Re: SPR2601-01: Dennington-Helgren New Single Detached Dwelling Unit, Detached Accessory Dwelling Unit, and Site Improvements, Final Plan Review & Public Hearing

Re: SPR2601-01: Dennington-Helgren New Single Detached Dwelling Unit, Detached Accessory Dwelling Unit, and Site Improvements, Final Plan Review & Public Hearing

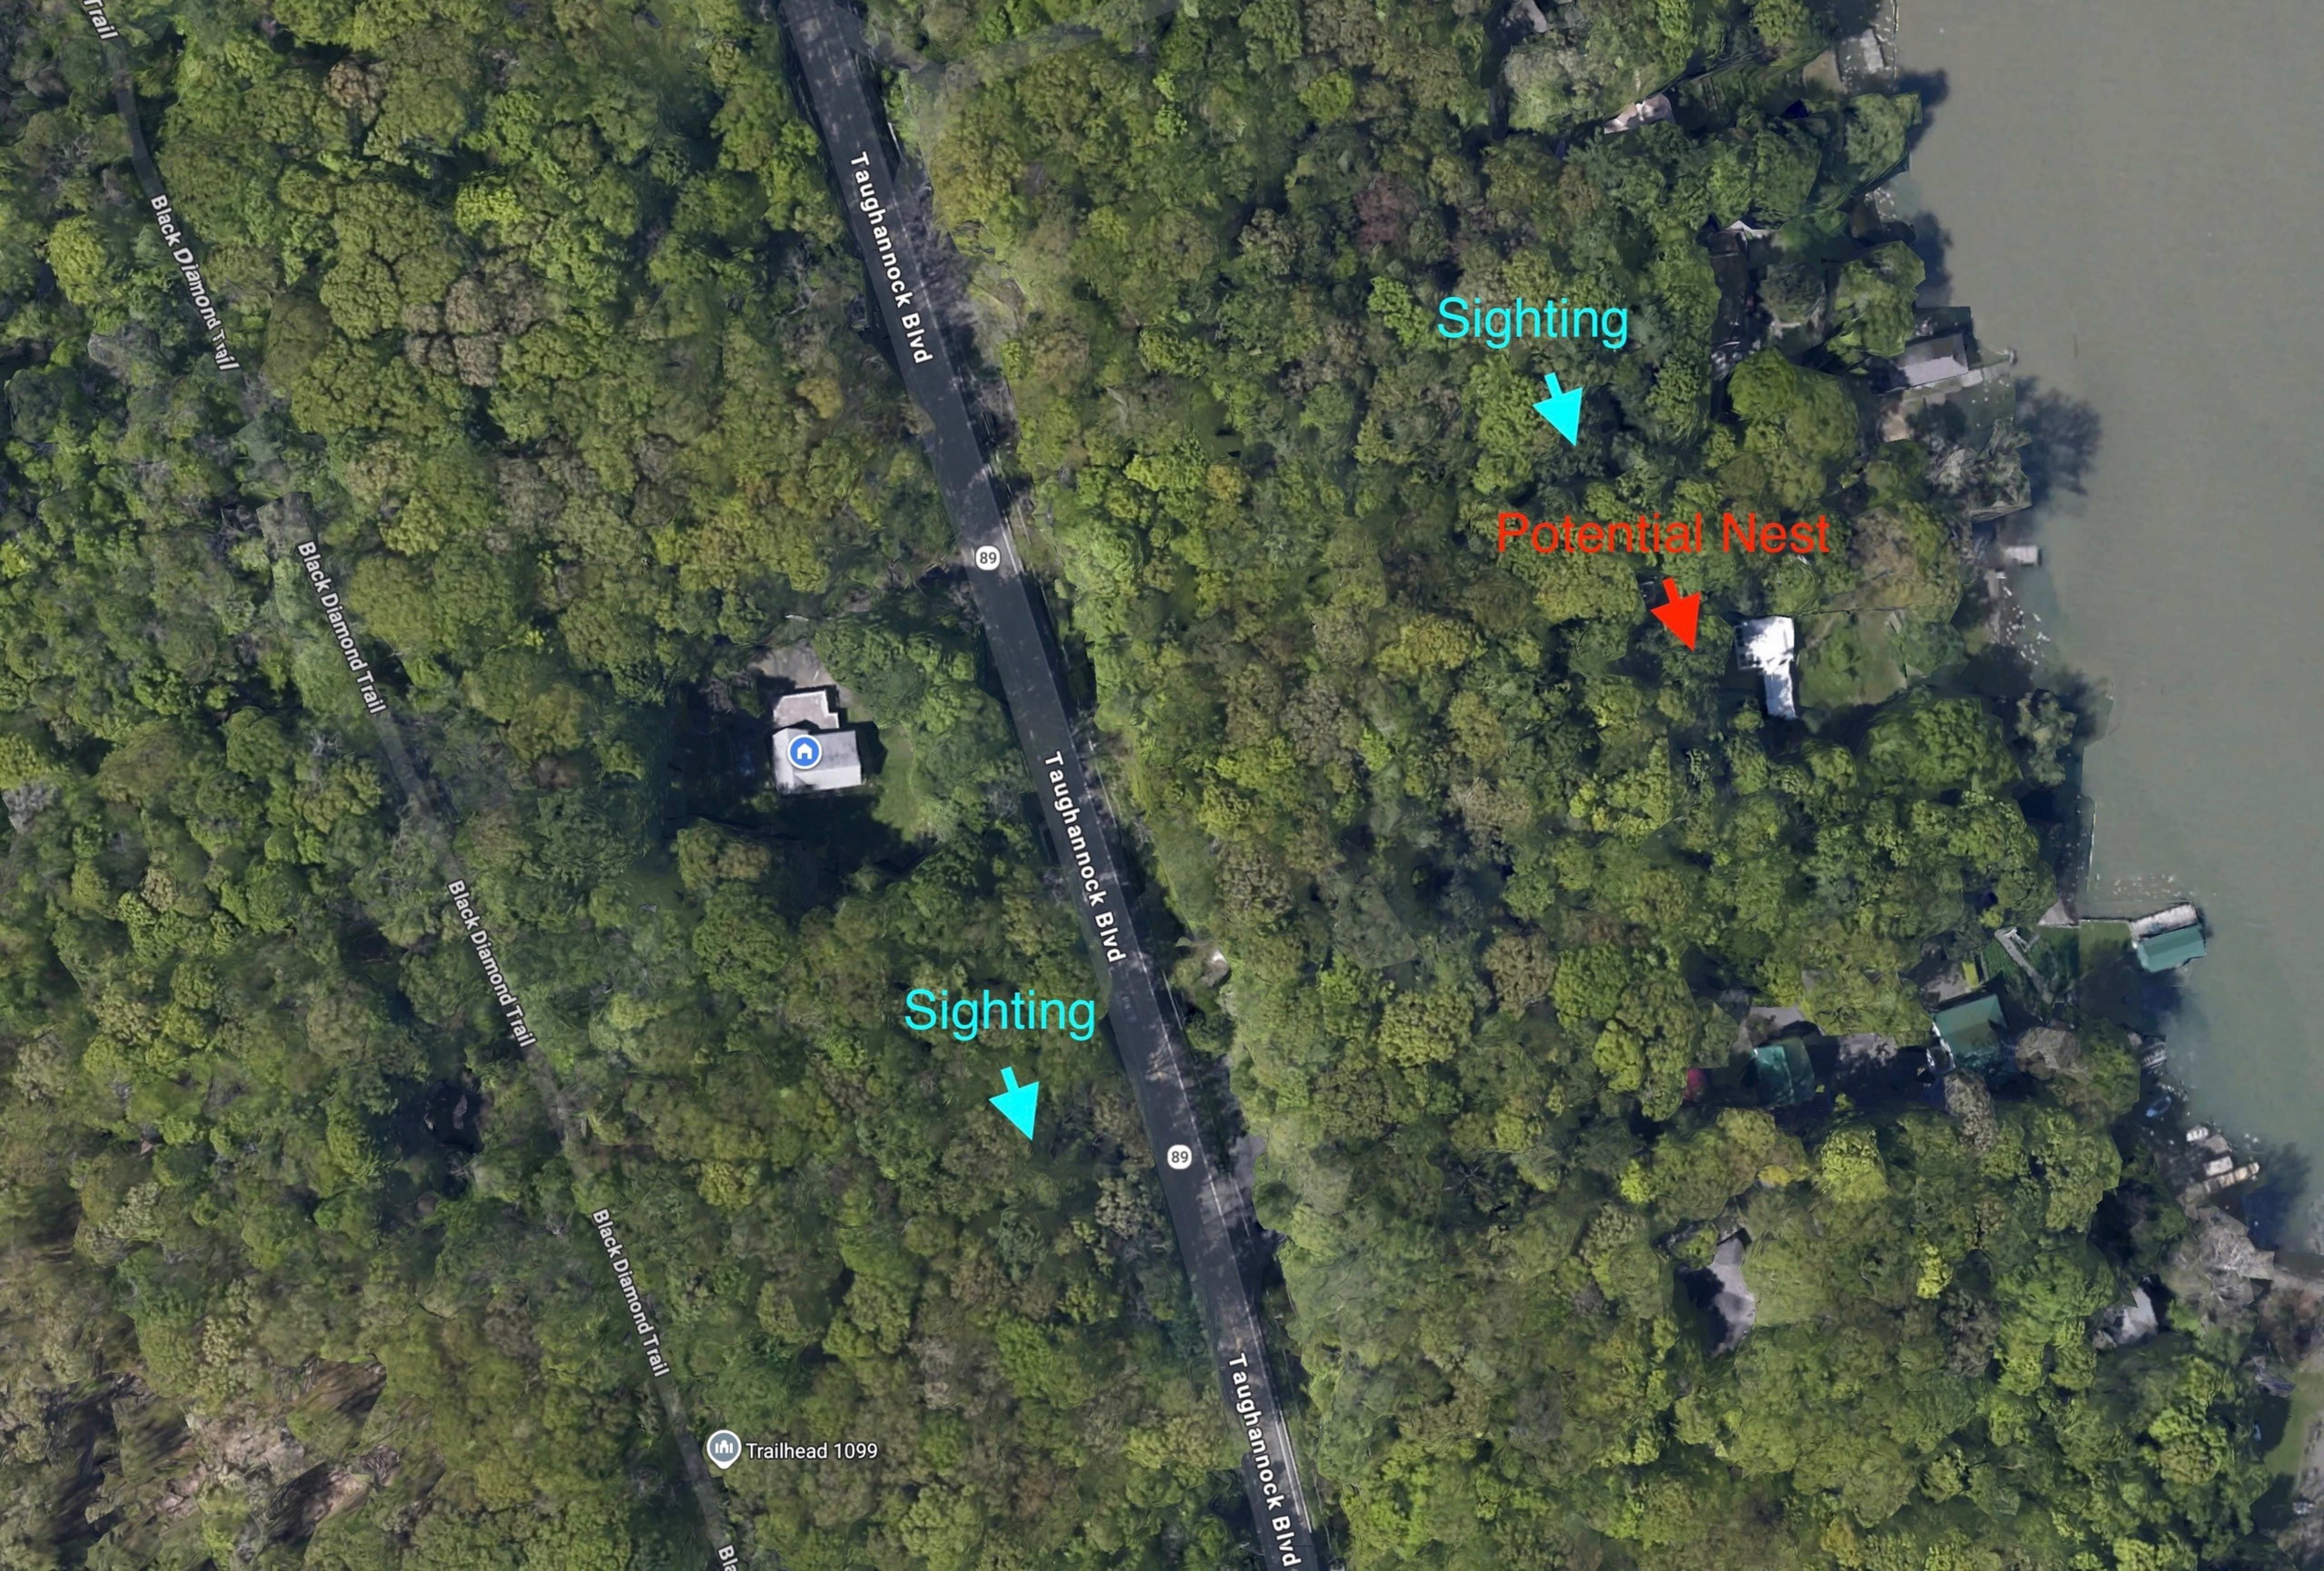
Finally, there is evidence of a bald eagle nest under 660ft from the project area. I ask the Board to determine whether further investigation is needed regarding the presence and status of the nest, potential construction impacts during the breeding season, and whether consultation with NYSDEC or the U.S. Fish and Wildlife Service is required before any approval or site disturbance.
